Entergy Nuclear Operations, Inc.
Pilgrim Nuclear Power Station
600 Rocky Hill Road
Plymouth, MA 02360

SUBJECT: Entergy Nuclear Operations, Inc.
Pilgrim Nuclear Power Station
Docket 50-293
License No. DPR-35

Response to NRC Request for Additional Information
Appendix K Measurement Uncertainty Recovery – Power Uprate Request

LETTER NUMBER: 2.02.096

Figure B.1 Pilgrim Primary Structure Seismic Model

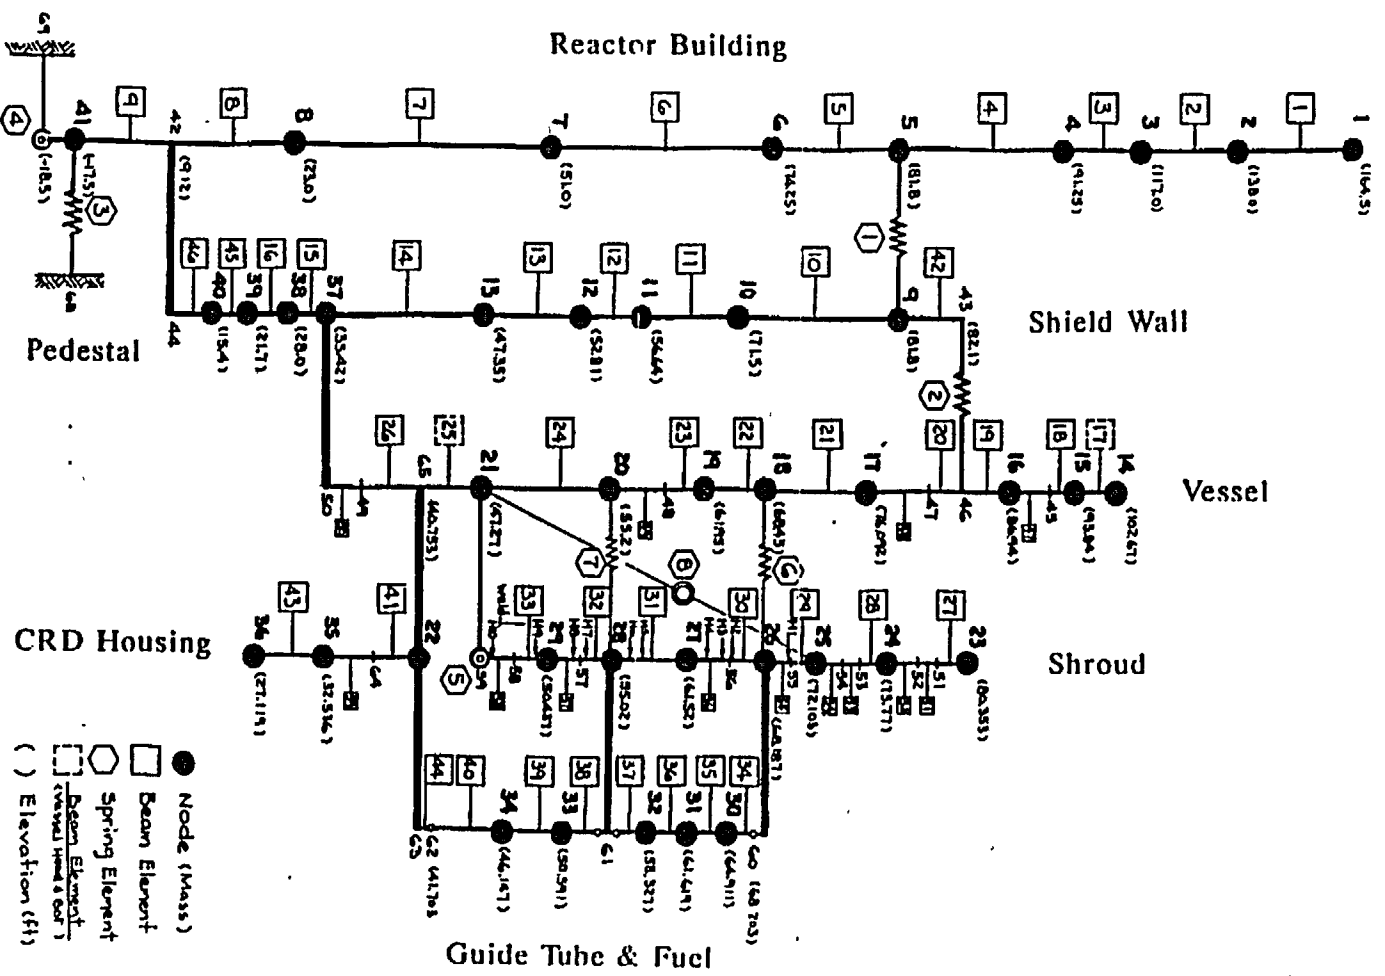
B. Provide the justification for using the RG 1.61 damping values instead of the licensing basis damping values, as shown in the FSAR, for application with the ISM approach."

ISM with SRSS Grouping. The recirculation piping is supported at multiple locations on various plant structures such as the RPV (Group 1), Reactor Building and Drywell (Group 2), and Shield Wall and Pedestal (Group 3). These structural groups generally have distinct associated vibration modes whose frequencies are spaced sufficiently far apart. The consequence of this frequency spacing is that the piping support motions from these structural groups are, in a statistical sense, uncorrelated. This fact alone provides sufficient justification for the SRSS combination of the piping responses due to each support group motion.

In a previous analysis of Pilgrim primary structure model (model data from DRF No. B11-00617-01, GE Report No. GENE 771-65-1094, Revision 2, March 1995) with fuel modification (use of GE14 fuel), the maximum accelerations at recirculation piping support point groups were obtained. The model used in that analysis is shown in Appendix B, Figure B.1. The primary frequencies of various structural groups are listed in Table B.1. Table B.2 records the times at which peak acceleration responses occur in different structural groups. The following discussion forms the basis for selecting Table B.2 node points on these structural groups.

The RPV support elevation for the various piping systems is 86.94 feet. Node 16 selected in Table B.2 corresponds to this elevation. Reactor Building and Drywell support locations are at 21.7 feet, 23 feet and 51.1 feet. The peak responses and response spectra at these nodes are enveloped by the node with the highest elevation, i.e., Node 7 at elevation 51 feet. Similarly,

Shield Wall and Pedestal support locations are at elevations 35.4 feet and 47.4 feet with envelopes of peak responses and response spectra obtained at Node 13, Reference 4.5.

Table B.2 lists the times at which peak acceleration responses are obtained at each of the nodes thus selected on the three structural groups. The minimum spacing between these peak response times occurs between the RPV and the Reactor building responses and is 0.135 seconds.
